Subject: 45 S Chestnut Ave. – Preliminary and Final PUD for 5-Story, 80 unit Residential Housing Development. Preliminary and Final Plat of Subdivision to consolidate lots, Rezoning from R-3 to R-7 and multiple Variations (density, setbacks, building lot coverage, F.A.R., and parking)

PC#: 17-016 - Round 2

PLAN COMMISSION PC #17-016
Sigwalt Apartments
45 S. Chestnut Ave.
PUD, Preliminary & Final Plat of Subdivision, Rezone, Variations
Round 2

Sigwalt Apartments
45 S. Chestnut Ave.
PC#17-016

OUTLET CONTROL STRUCTURE

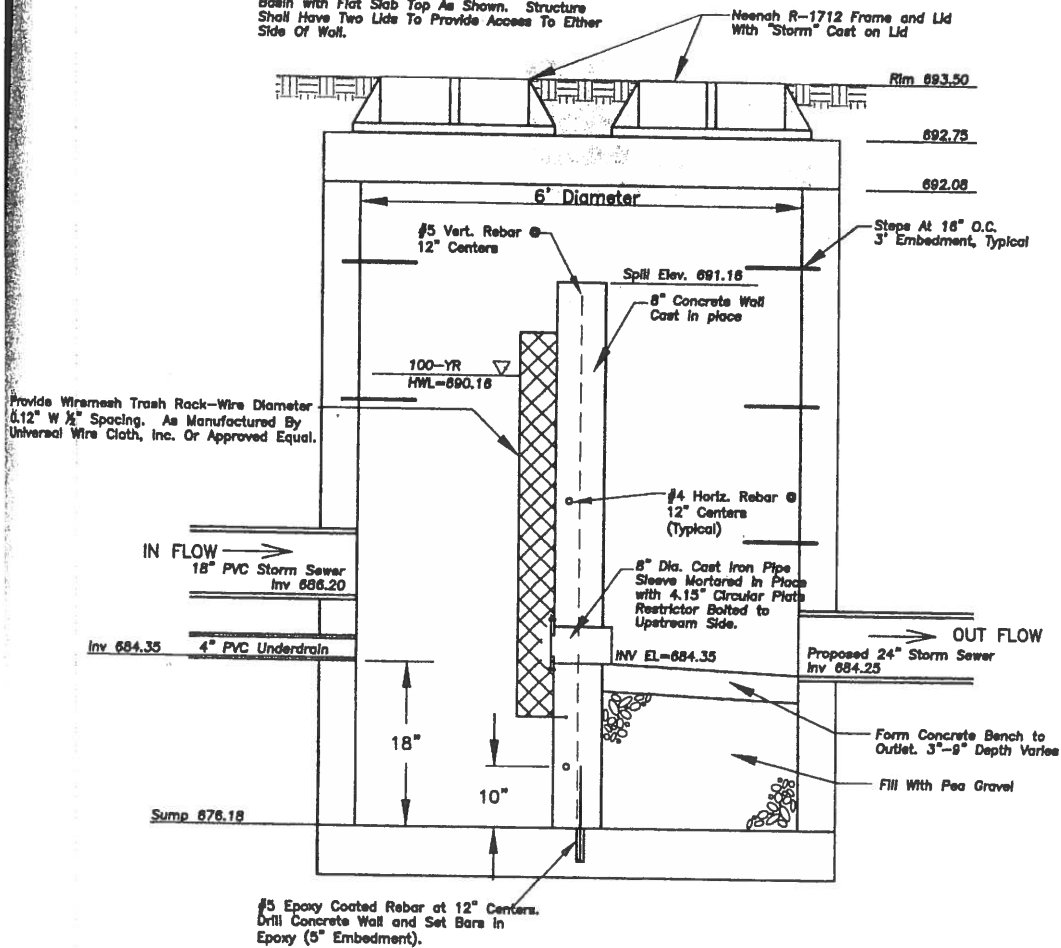
- 23. The responses made by the petitioner to comments #11-15 & 18-22 are acceptable
- 24. The response made by the petitioner to comment #16 is noted. Restrictors between 2" and 4" must have a trap. The trash rack shown on the attached "Outlet Control Structure Detail" can be specified instead of a trap. This can be shown in the permit plans.
- 25. The response made by the petitioner to comment #17 is noted. Provide the catalog cuts for all building mounted luminaires at permit submittal. All fixtures must be flat bottom, sharp cut-off, and no wall pack style fixtures will be permitted.

Note:
Structure Shall Be Modified 6" Diameter Catch Basin with Flat Slab Top As Shown. Structure Shall Have Two Lids To Provide Access To Either Side Of Wall.

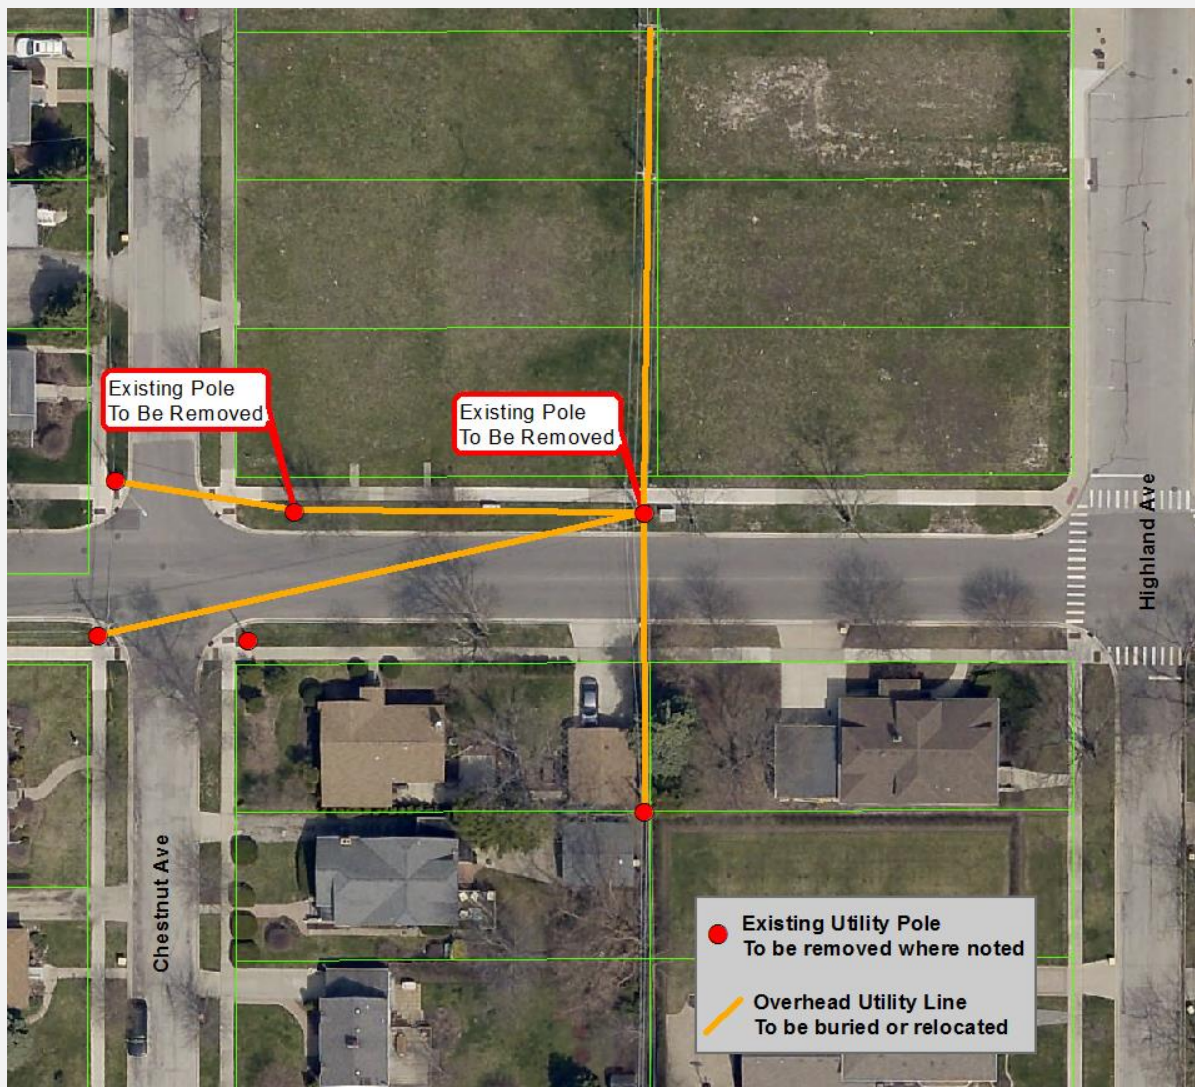
21. The response to comments #7-#10, #12-#18, and #20 are acceptable.
22. The response to comment #11 is noted. For clarification, please see the graphic below, which represents the utility pole and utility lines that the Village is asking be relocated or buried. The feasibility of the burial/relocation of these utility lines and poles will be determined in conjunction with all utility companies.
